Date	08/27/18
Checked By	AMH
Drawn By	TLW
Revision Number	01
Revision Description	WCD #8 - SAN PIPE REPLACEMENT
Designed By	TLW
Drawn By	SJB
Checked By	SJK
Approved By	SJK
Filename	400-PP-1_WCD.DWG
Project No.	13241
Project Date	12/28/2017

CITY OF SUPERIOR, WISCONSIN
NEWTON CREEK AND NELSON CREEK TRUNK SEWERS

PLAN AND PROFILE
NEWTON CREEK

400-PP-2

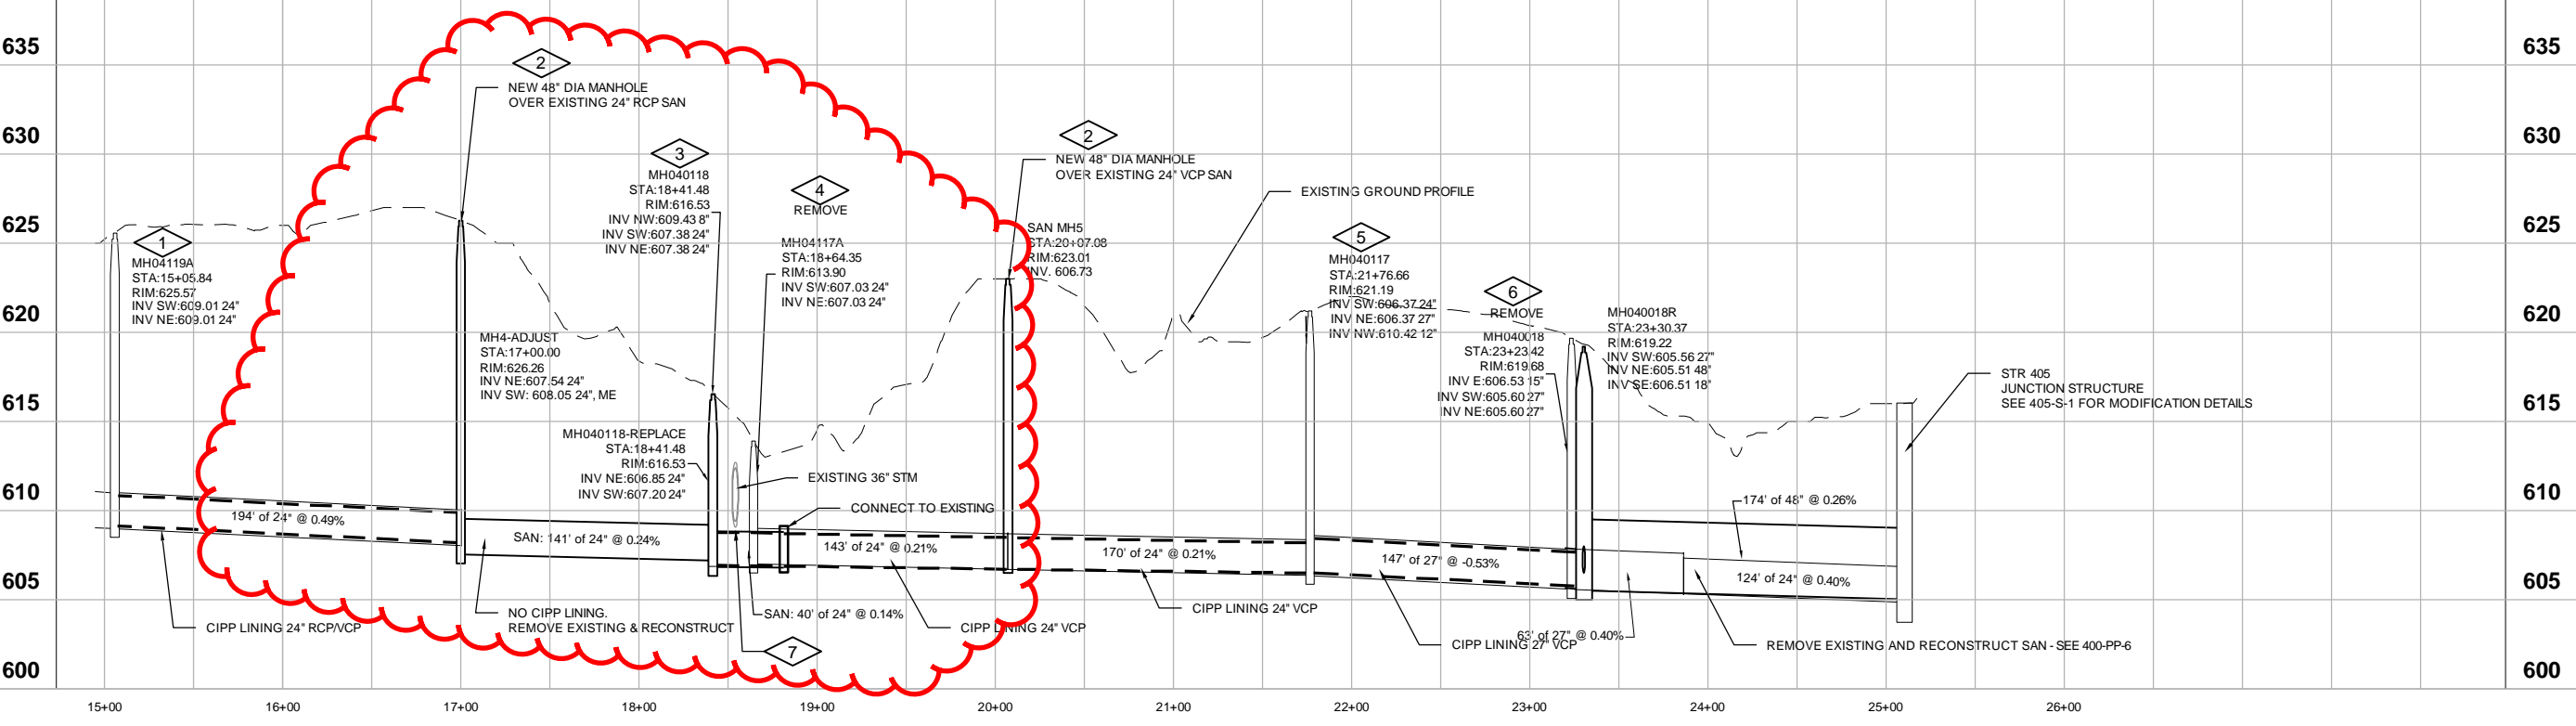
1. MH04119A - EXISTING BRICK MANHOLE CONSTRUCTED 1904. NO CONNECTION NW. CIPP LINING TO EXTEND THROUGH STRUCTURE. CONTRACTOR TO ABANDON SANITARY MANHOLE. MINIMIZE DISTURBED AREA NEAR NEWTON CREEK.

2. NEW 48" DIA. PRECAST CONCRETE MANHOLE OVER EXISTING 24" SAN. FIELD VERIFY LOCATION AND DEPTH. RESTORE BITUMINOUS PAVEMENT. REVISED LOCATION. RESTORE DISTURBED SURFACES TO MATCH EXISTING, INCLUDING CONC SIDEWALK.

3. MH040118 - EXISTING BRICK MANHOLE CONSTRUCTED 1904. REMOVE EXISTING BRICK CONE AND REPLACE WITH PRECAST CONCRETE CONE. PROVIDE CHIMNEY SEALS, NEW CASTING AND REHABILITATE MANHOLE. MINIMIZE DISTURBED AREA NEAR NEWTON CREEK. REMOVE ENTIRE STRUCTURE AND REPLACE WITH 48" DIA. PRECAST CONCRETE MANHOLE. PROVIDE CHIMNEY SEALS AND SOLID CASTING. RESTORE EMBANKMENT WITH WETLAND SEEDING.

4. MH04117A - EXISTING CONC MANHOLE. NO CONNECTION NW. CIPP LINING TO EXTEND THROUGH STRUCTURE. CONTRACTOR TO ABANDON SANITARY MANHOLE. MINIMIZE DISTURBED AREA NEAR NEWTON CREEK. REMOVE MANHOLE.

5. MH040117 - EXISTING BRICK MANHOLE CONSTRUCTED 1904. REHABILITATE MANHOLE. PROVIDE CHIMNEY SEALS AND NEW CASTING. MINIMIZE DISTURBED AREA NEAR NEWTON CREEK.

6. SEE 400-PP-4 FOR ENLARGED PLAN & PROFILE FROM MH040018 TO LIFT STATION 5.
7. RECONSTRUCT SANITARY SEWER BENEATH EXISTING 36" RCP STORM OUTLET PIPE. REMOVE AND RESET STORM PIPING, PROVIDE JOINT TIES AT LAST 3 JOINT UPSTREAM OF STORM OUTFALL PER WISDOT SDD 8F4. BEDDING AND BACKFILL COMPACTION AROUND NEW 24-INCH SANITARY PVC SHALL BE FIELD TESTED AT THE LOCATION OF THE SEWER CROSSING. PROVIDE 3/4-INCH PRESSURE-TREATED PLYWOOD (8 FT BY 8 FT AREA) OVER SANITARY BACKFILL IN LOCATION OF STORM SEWER CROSSING. PROVIDE 1-INCH RIGID INSULATION OVER PLYWOOD. CONTRACTOR SHALL FIELD VERIFY COVER DEPTH, IF POSSIBLE PROVIDE 2-INCH RIGID INSULATION.
